Packet Index and Revision Control

Six artifacts assembled from CAD, network, electrical, and RFI exports

RFI-214B Markup and Final Answer

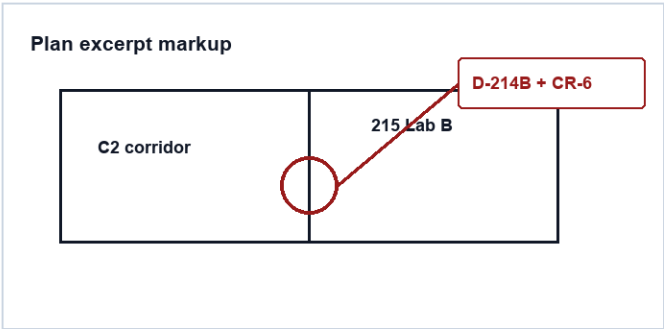
Question: Door label conflict. CAD Rev B shows D-214A at Lab B corridor. Field sticker and security rough-in show D-214B. Which label controls for access control schedule?

Response: Use D-214B for the Lab B corridor door. Add CR-6 card reader on corridor side. Update access control schedule and panel LP-2 circuit L2-15. Rev C dated 2026-06-12 controls.

Field	Rev B	Rev C final
Door label	D-214A	D-214B
Reader	none	CR-6 corridor side
Circuit	unassigned	L2-15
Schedule status	draft	issued
